**Early Site Review Report
for the
Sundesert Site
San Diego Gas & Electric Company**

NUREG-0171

EARLY SITE REVIEW REPORT

SUNDESERT SITE

FIGURE 2.2 LAND OWNERSHIP - SUNDEERT SITE

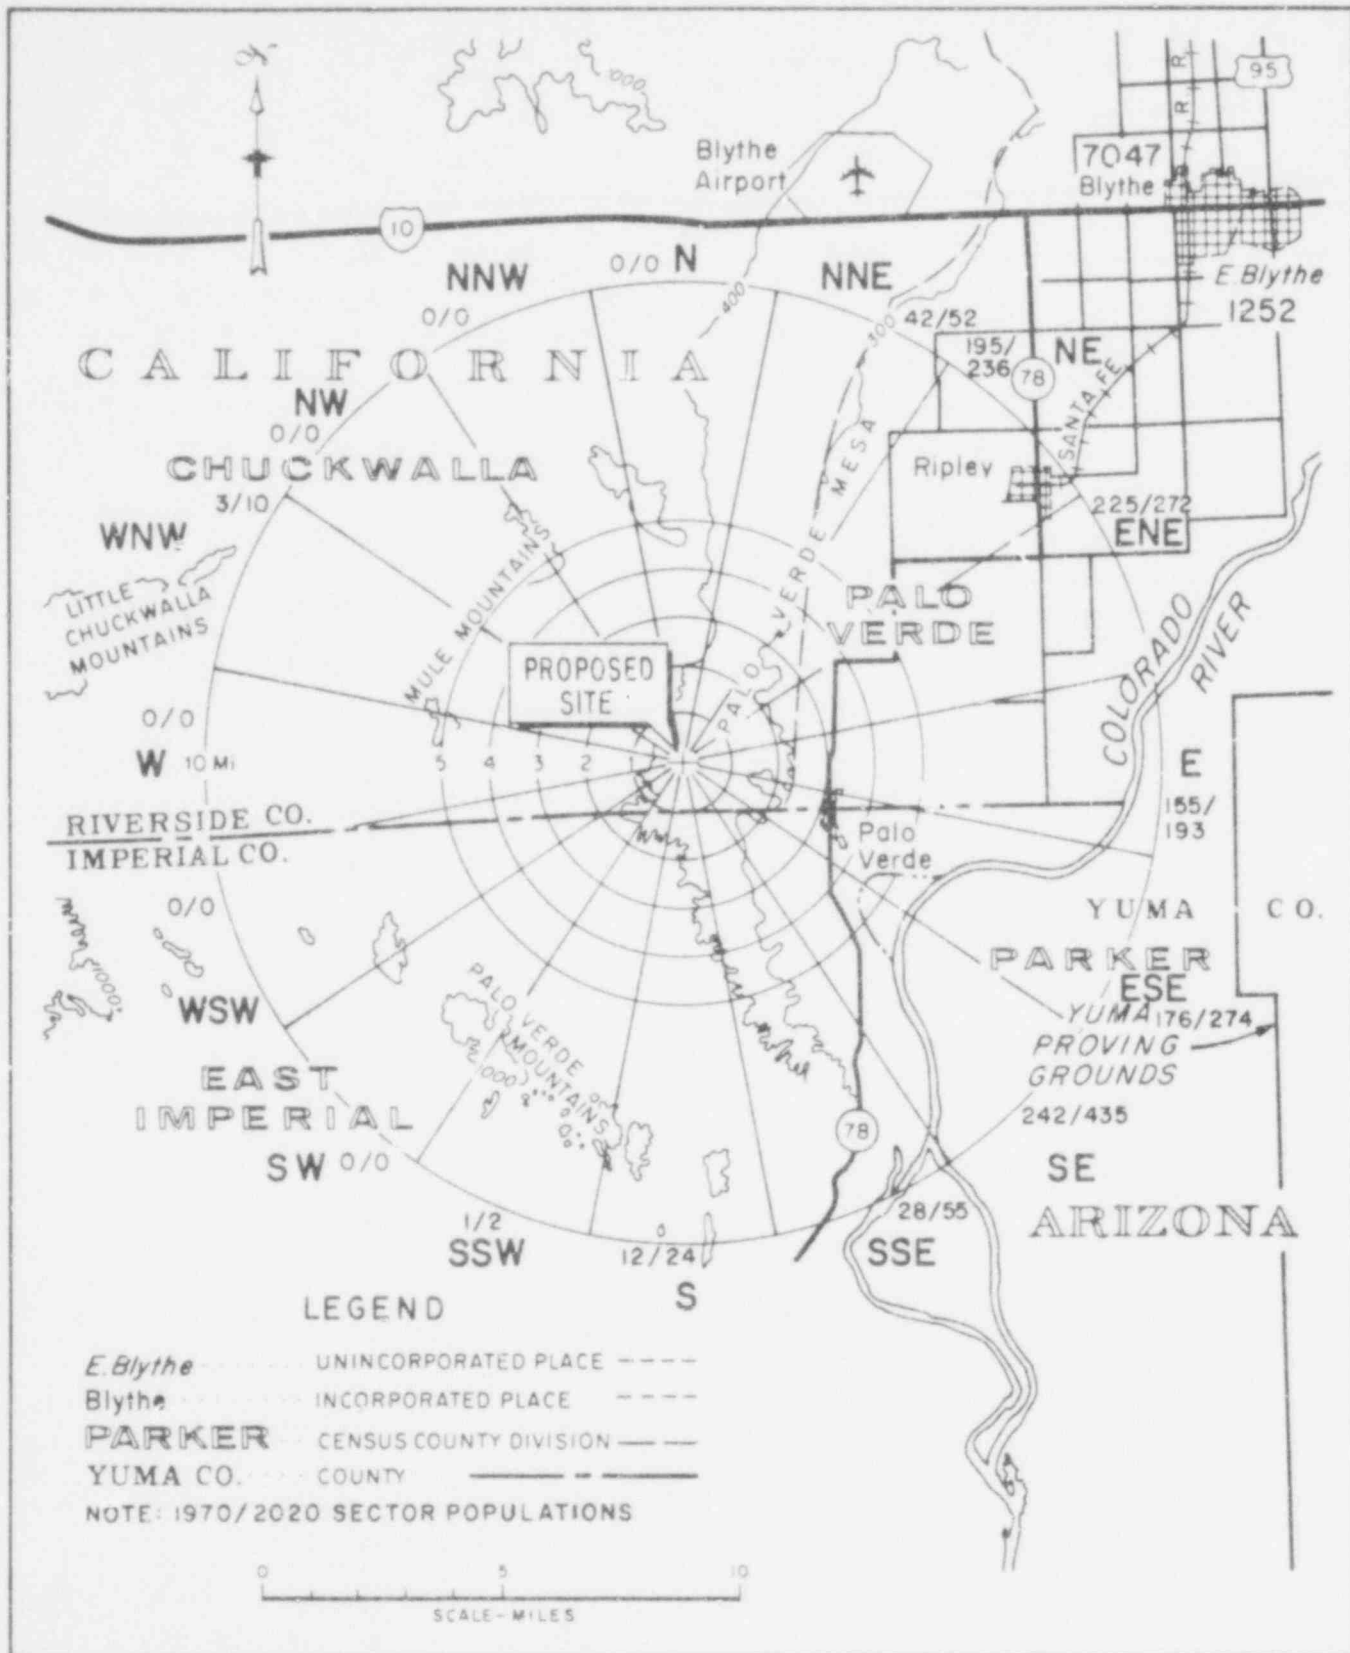
The applicant has defined a site boundary and exclusion area radius of 3,200 feet as shown in Figure 2.2. The applicant proposes to acquire land (shown as Parcel No. 1 in Figure 2.2), consisting of about 6,560 acres, from the U.S. Department of Interior, Bureau of Land Management through an in-lieu property exchange. To this end, the Bureau of Land Management has designated lands, in the Coachella Valley region in California, which it is interested in acquiring by exchange. The applicant has optioned the land designated by the Bureau of Land Management for the property exchange. Based on the Bureau of Land Management's land exchange practices, the applicant will acquire 100 percent of the mineral rights in about two-thirds of the land to be acquired from the Bureau of Land Management. However, the applicant will acquire from the Bureau of Land Management 100 percent of the mineral rights in all the land within the exclusion area.

The applicant has optioned, with the exclusive right to purchase, the land shown as Parcel Nos. 2, 3, 4 and 5 in Figure 2.2. The options to purchase held by the applicant include 100 percent of the mineral rights, except for Parcel No. 2 (which is not in the exclusion area) where the optionor has reserved 50 percent of the mineral rights. An option to purchase the land shown as Parcel No. 6 in Figure 2.2 has been tendered to the owner, who declined to enter into an option agreement. The parcel is not within the exclusion area and therefore control, including mineral rights, is not required.
